AppSer. No. 09/854,304

AUTO-ADJUST NOISE CANCELING MICROPHONE WITH
POSITION SENSOR

Reply to Office Action of July 9, 2004
Annotated Sheet Showing Changes

FIG. 1

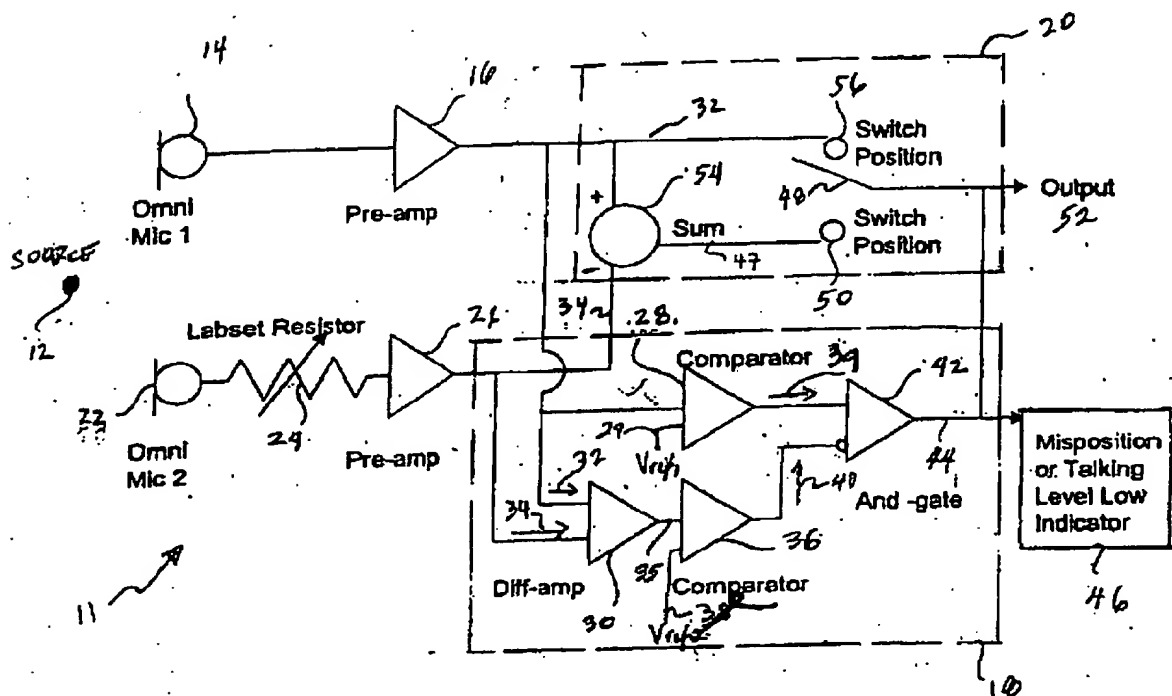
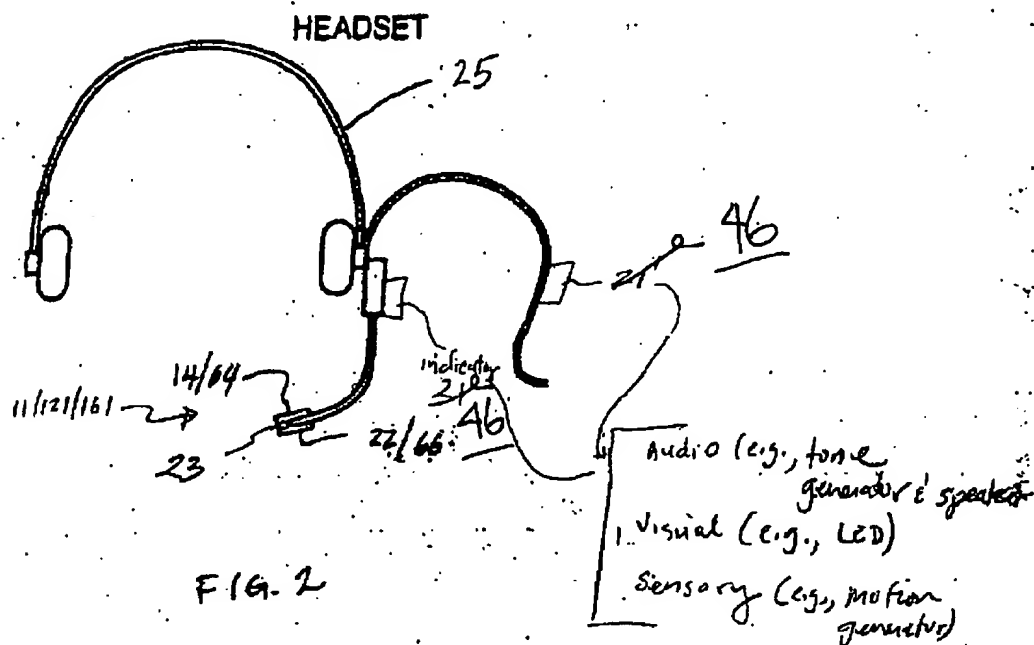
Some minor errors are also corrected in FIGS. 1-3. In particular, in FIG. 1, reference number 38 is removed as the specification does not contain reference to 38.

FIG. 3

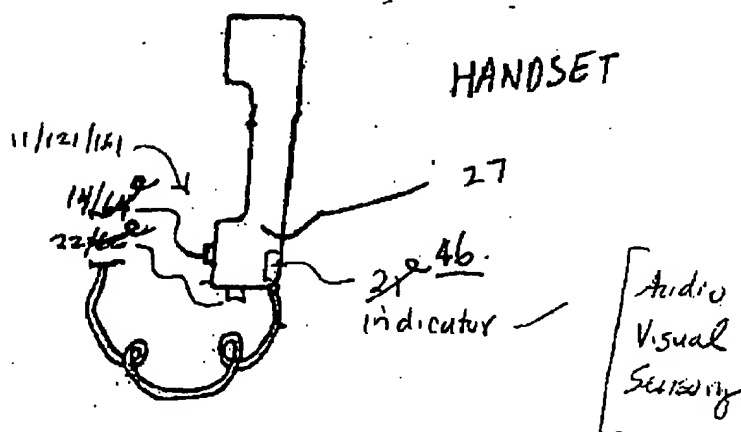
In both FIGS. 2 and 3, reference numbers 64 and 66 are removed as the specification does not contain reference to 21, 64, or 66. In addition, in both FIGS. 2 and 3, each instance of reference number 21 is corrected with reference number 46.
